**Re: SPPL2023227
MN 600 Norfolk St N,
Simcoe, Ontario
Proposed Eighteen (18) Unit Stacked Condo
Engineering Comments 1st Submission
Norfolk County**

SITE DEVELOPMENT PLAN (Dwg. No. 15598-1):

LANDSCAPE PLAN (Dwg. No. 15598-2):

ARMOURSTONE RETAINING WALL

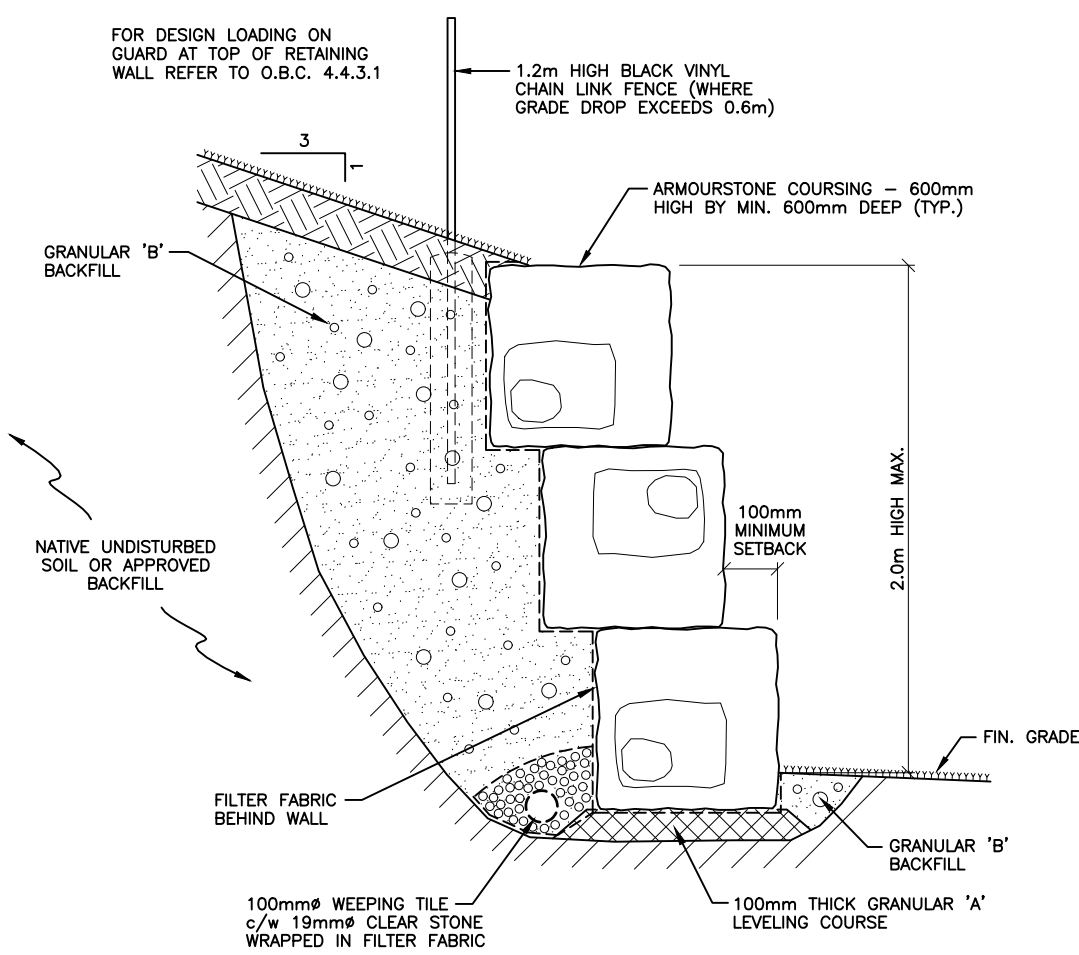
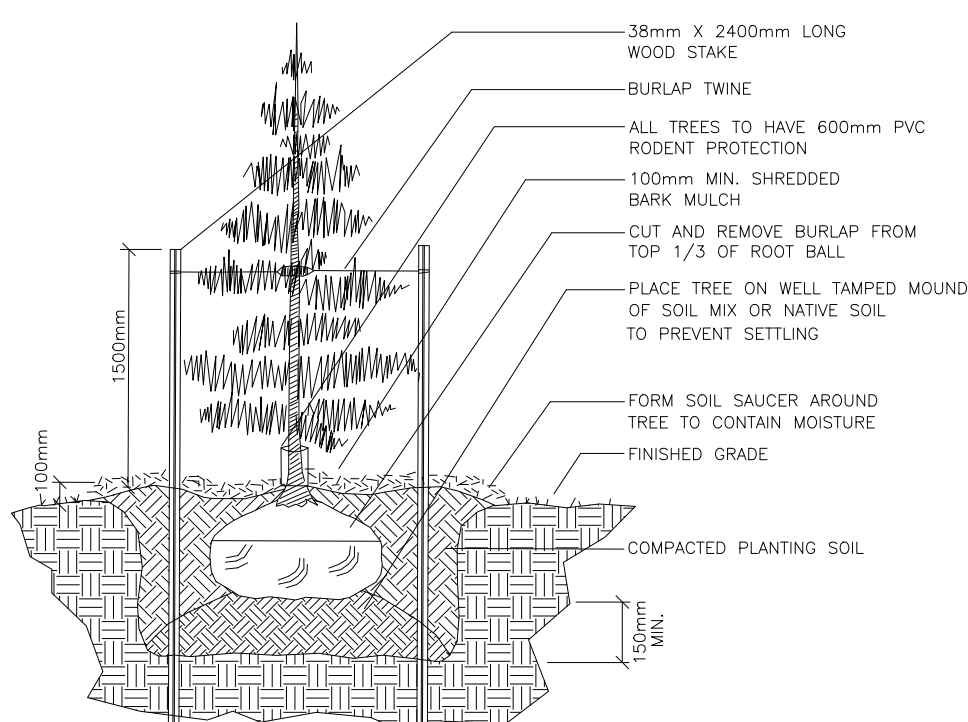
21. It appears that sections of the proposed retaining wall will exceed 0.6m in height. It is the opinion of Development Engineering that heights over 0.6m will require a building permit and may require an Engineered Stamp. In your next submission please confirm all requirements for the final wall design. This retaining wall shall be identified in the securities at 100% as it may affect the neighbors.

23. Please note that Development Engineering has not reviewed or Approved the Retaining wall design shown on this drawing. All approvals are to be granted by others. All retaining walls are to be shown in the securities at 100%.

The retaining wall meets the requirement for a separate building permit application. site plan has been updated accordingly. A detail (stamped) is an acceptable engineered solution (although various products are available to the developer to consider that will continue to meet the requirements.

SITE DEVELOPMENT PLAN

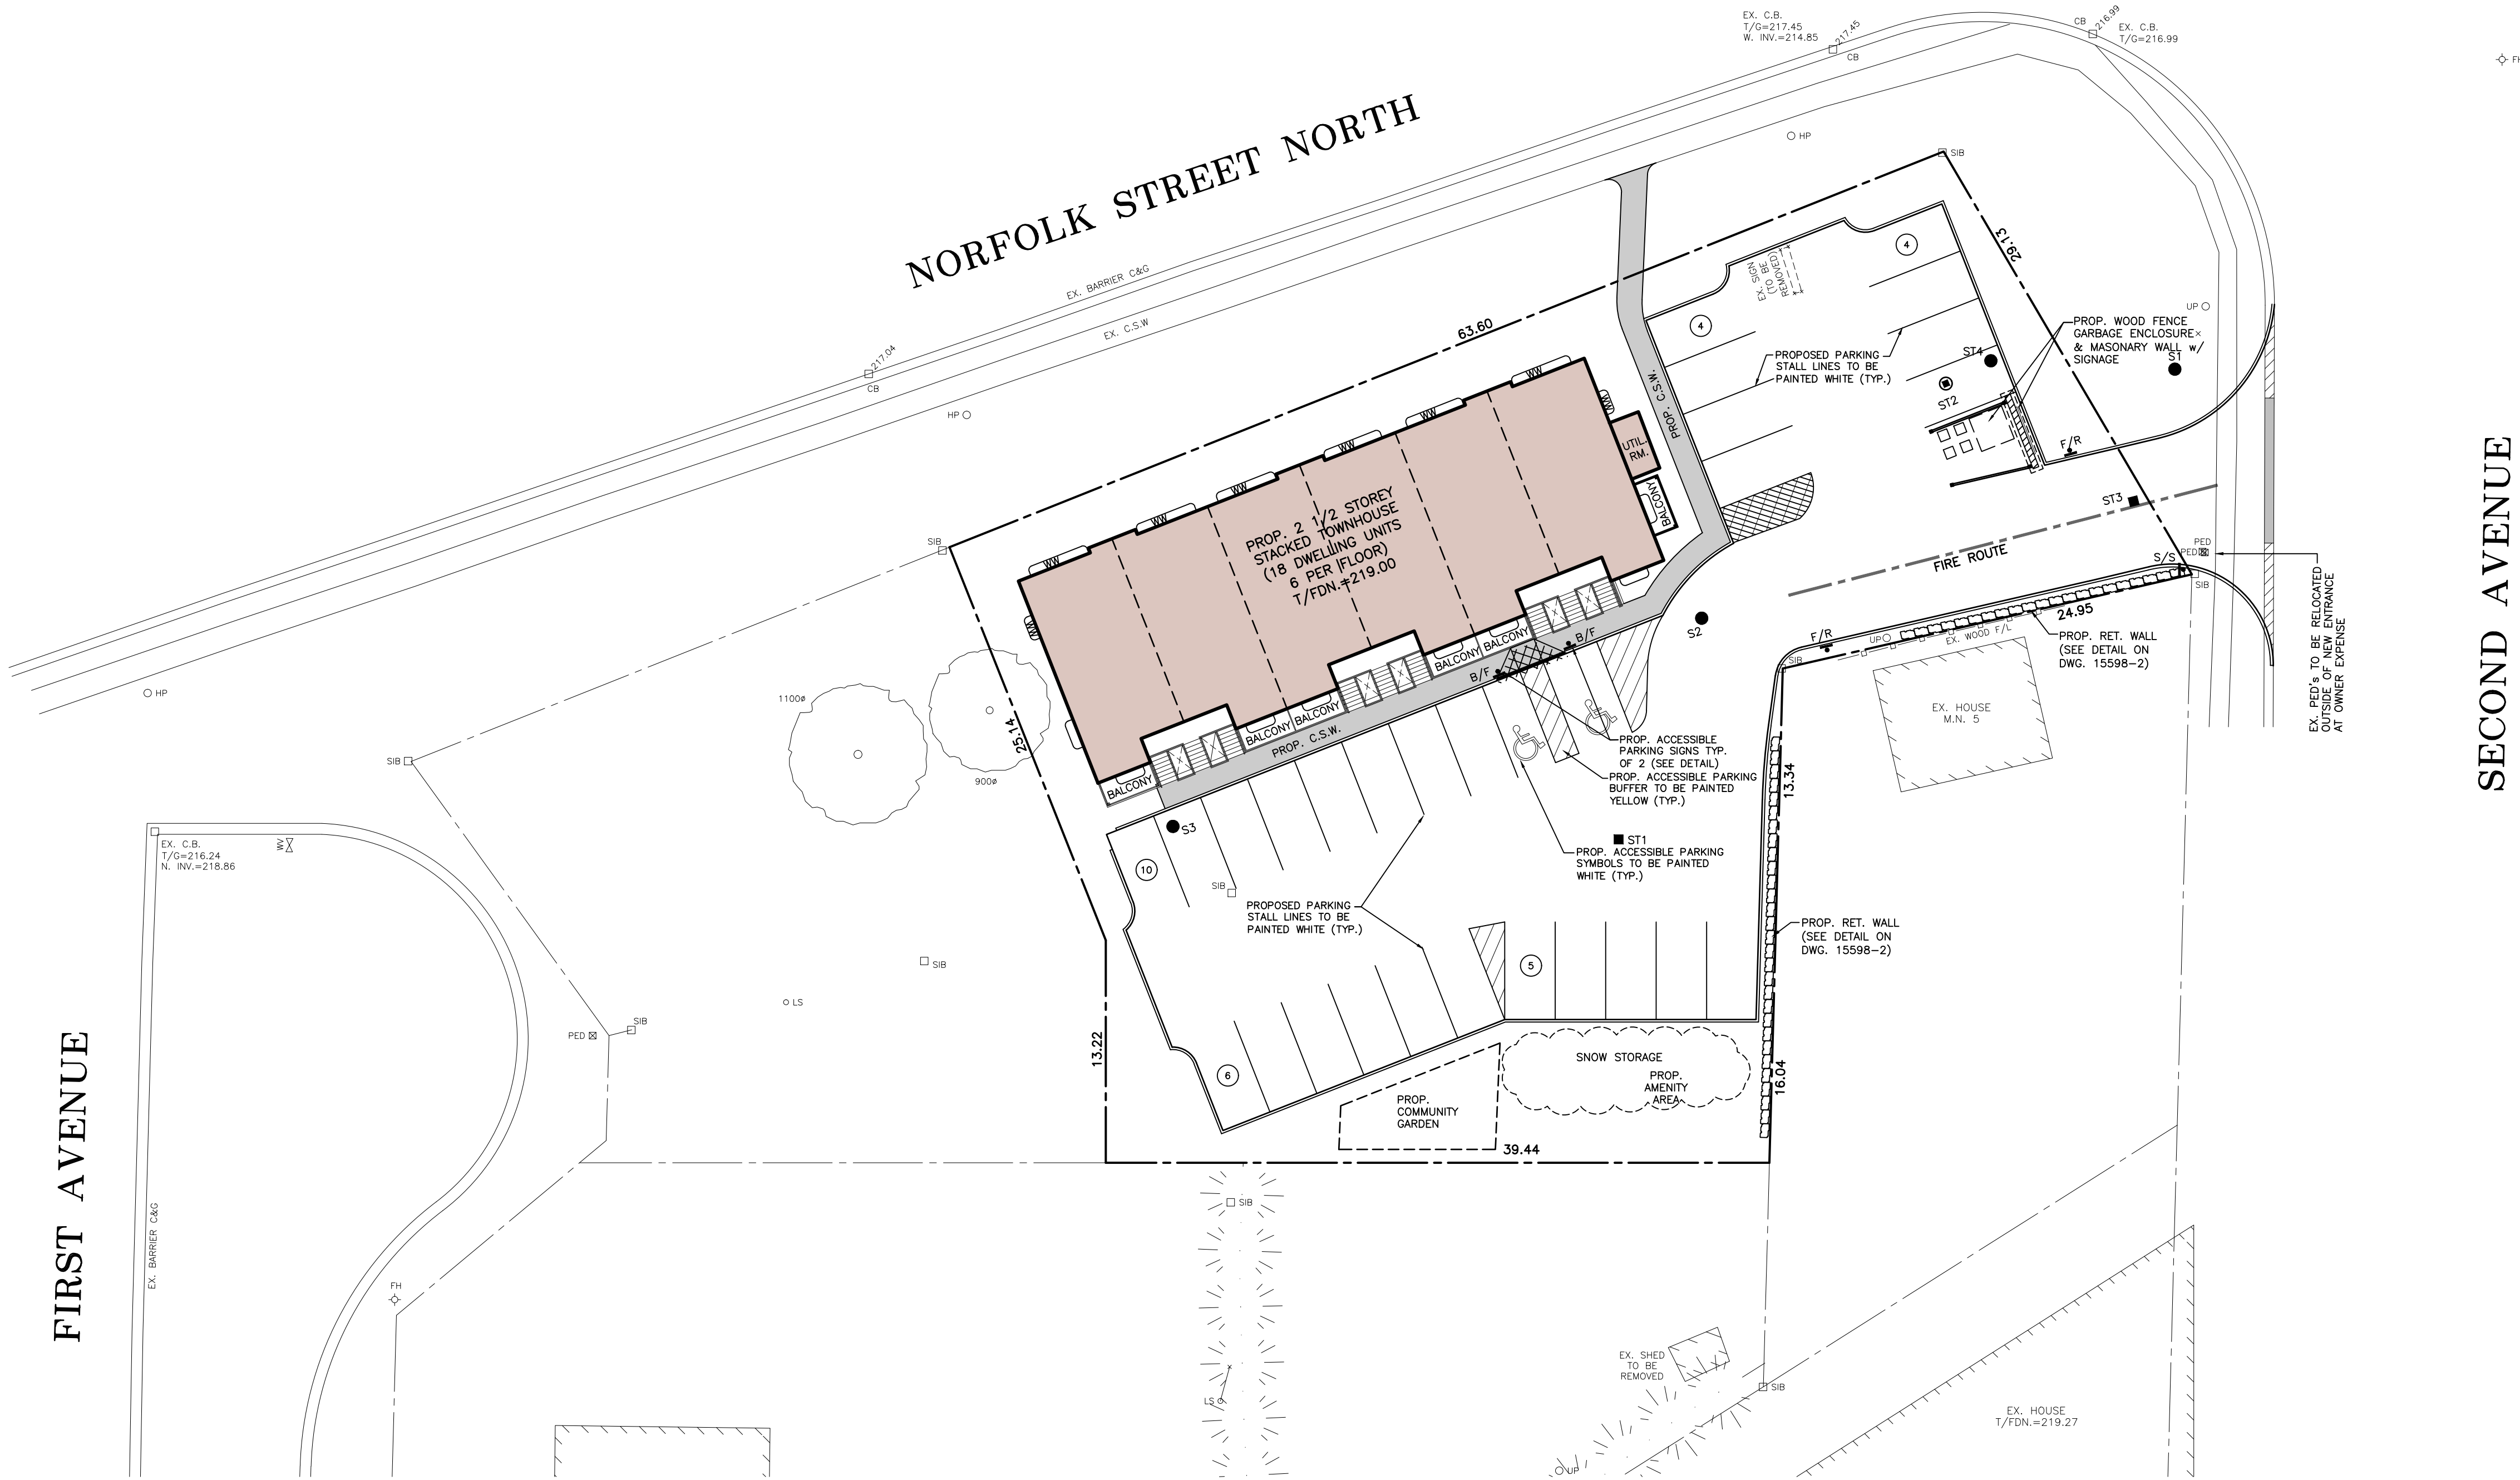
9. Please identify the location of Roof water leaders. The locations shall ensure all roof water is directed to the proposed SWM areas. No roof water shall leave the site unattenuated.

12. The proposed water service shows a bend within the County ROW. Bends are not permitted within the County ROW. On your next submission please have the water service extended to property line perpendicular to the main and then bend at the Property line valve (CS) and travel in a straight line to the building.

13. Please show the Property line Curb Stop valve on the proposed water service.
The site plan has been updated accordingly.

16. The sanitary Lateral is shown to have a bend within the County ROW. Please be aware that bends are not permitted within the County ROW. In your next submission please extend the Sanitary lateral to the property line and then place the Inspection manhole.

19. This drawing identifies that the Orifice plate is to be in ST1. However, this would mean that much of the site is not controlled for stormwater. Please review the stormwater design and relocate the Orifice plate to the structure that will protect the entire site.

a. If all existing storm sewers on site are being removed, then will it be appropriate that the Orifice should be placed in ST4? Please confirm.

b. As mentioned in Comment 4 the sizing seems large for a site this small. Please confirm calculations for 100mm orifice are correct.

20. Please label the size of existing storm sewer leaving the site onto Municipal property. Confirmation that this existing storm sewer is adequate is required.

22. It appears there is an existing communications pedestal located in the new driveway. Please add a note to the drawing that the Pedestal is to be relocated at the Developers expense. Also please confirm that the Utility has been notified and is aware of this relocation. The cost of relocating the pedestal is to be included in the Securities at 100%.

The proposal has been updated to address the concerns / comment above. We note tat the stormwater management analysis previously (and now augmented) will restrict the runoff from this site to the pre-development levels (whether or not the flow is directed through the storm sewer system) and therefore, the Norfolk County criteria is being achieved.

Although we have complied with the request, we would like to point out that the County during the reconstruction project included a water service (as illustrated on the plan) that "kinked" to the property line.

The site plan has been updated accordingly.

Please review the comments above.

The site plan has been updated accordingly.

The Cost Estimate has been updated accordingly.

FLOW CONTROL DEVICE ORIFICE PLATE
N.T.S.

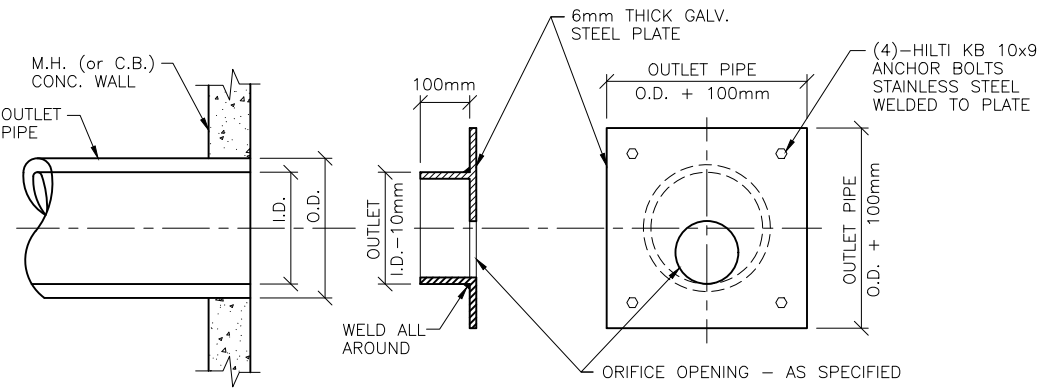
4. In the FSR it identifies that the orifice in ST1 is to be 100mm. This orifice must be moved to a structure that properly restricts the Stormwater discharge for the entire site. Please re calculate the orifice size for the entire site. It seems that this orifice is quite large for such a small site. However, it is recognized that the minimum size of Orifice according to the Stormwater Management Planning and Design manual shall be 75mm Dia.

Subsequent to the discussion held with Mr. S. Gradish of Norfolk County, we have included an additional orifice plate at the location identified which will protect the downstream storm sewer system from surcharging as a result of large storm event. We note that the analysis carried out on this site, resulted in the post development flows being reduced to the pre-development levels with only the required orifice plate. The additional orifice plate that is being proposed is located within ST4.

= 125mm
